Subject: LADWP BRRTP Crossing #16-4 to 16.5
(Oak Creek Rd x Pipeline Rd, Mojave)
Barren Ridge S.S. to Haskell S.S. T.L. R/W
Windhub-Goldtown-Monolith-Windlands 66kV T/L
APN 237-562-35
SCE File No. CON203053239

Southern California Edison Company (SCE), has reviewed and approved your request for Department of Water and Power, City of Los Angeles (LADWP) crossing the SCE Transmission Line shown on the attached plans entitled "Crossing at Southern California Edison Span 16-4 to 16-5, Drawing Number L83-SCE-16-4, sheet 1 of 1, dated June 29, 2015, date stamped approved by RP on August 21, 2015.

| REVISION | | | CROSSING AT SOUTHERN CALIFORNIA EDISON SPAN 16-4 TO 16-5 BARREN RIDGE S.S. TO HASKELL S.S. T.L. R / W | | | |

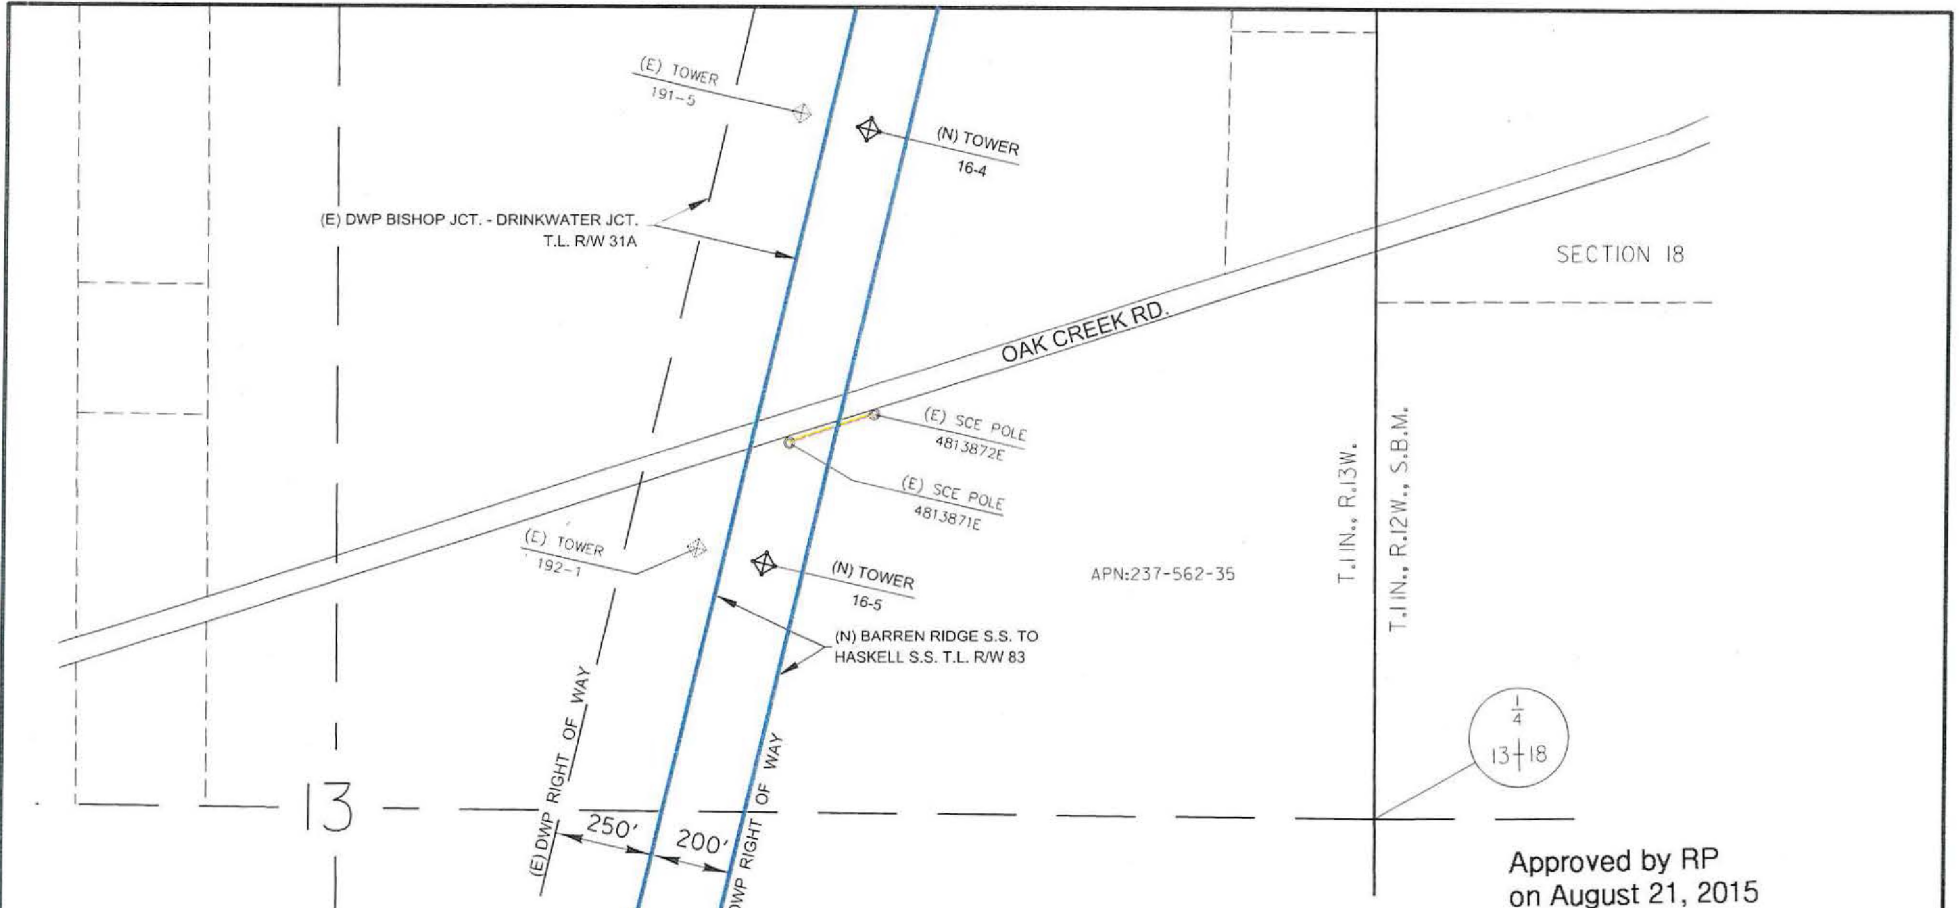
1. Adequate access to all structures must be provided and at no time is there to be any interference with the free movement of SCE's equipment and materials. (See Addendum 1 Table 1 - Standard Clearances)

2. At no time shall access to any SCE's facility be cut off or impeded in any way during any temporary grading operation.
3. All equipment working on the right of way must maintain a minimum clearance of 25-feet from all SCE structures in conjunction with the minimum clearances set forth in the California Code of Regulations, Title 8 Section 2946, Article 37 "Provisions for Preventing Accidents Due to Proximity to Overhead Lines" The minimum required equipment clearances also include SCE's Operating Conditions in which a minimum distance shall be maintained from all overhead conductors. (See Addendum 2 Table 2) If this minimum clearance cannot be maintained for any reason, LADWP will notify SCE and SCE may (at their own discretion), order an outage at the sole expense of the LADWP.

14. Underground facilities installed on the right of way shall have a minimum cover of Three feet (up to Seven feet depending on facility type and location). The ground cover shall be a minimum of Five feet where the underground facility crosses access roads that are earthen. All underground facilities shall be capable of withstanding a gross load of 40 tons on a three-axle truck. All pipelines and underground facilities must conform to ASTM standards as well as any State and Local agency requirements and specifications.

15. Horizontal underground clearances from SCE structures or facilities must be a minimum of Ten feet. Vertical underground facilities clearances from SCE structures or facilities must be a minimum of Three feet, and possibly up to seven feet (depending on type of crossing and voltage). If underground crossings to SCE facilities are made by water lines, LADWP shall be responsible for potential underground installations that result in induced voltages (i.e. Cathodic Protection)

21. Cribbing and safety measures shall be installed if the ditch is to be left open or endangers SCE facilities.
22. All mechanical equipment, including trenchers, working on the right of way must maintain a minimum clearance of two (2) feet from all underground structures.
